SIB 72 02 24

**RECALL 24V-288: HEAD AIR BAG LEFT**

This Service Information Bulletin (Revision 2) replaces SI B72 02 24 **dated September 2024**.

**Installation Note for F30 and F80 ONLY.**

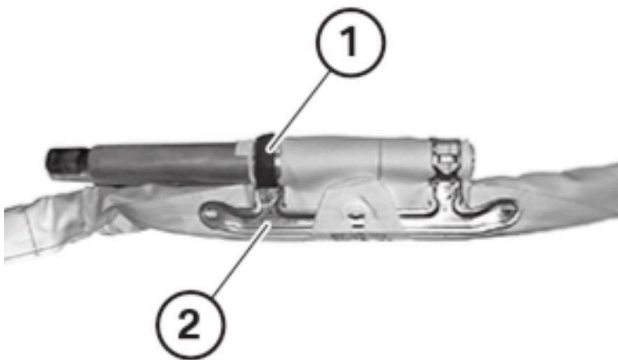
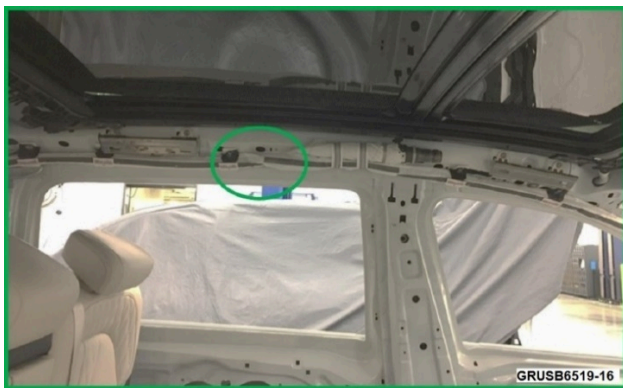
Felt (1) must be bonded to the gas generator holder (2).

Cut felt to length 15 mm x 50 mm x 1 mm

To ensure correct function for deployment, the head air bag must be positioned so that the printed, colored line points towards the vehicle interior across the entire component length.
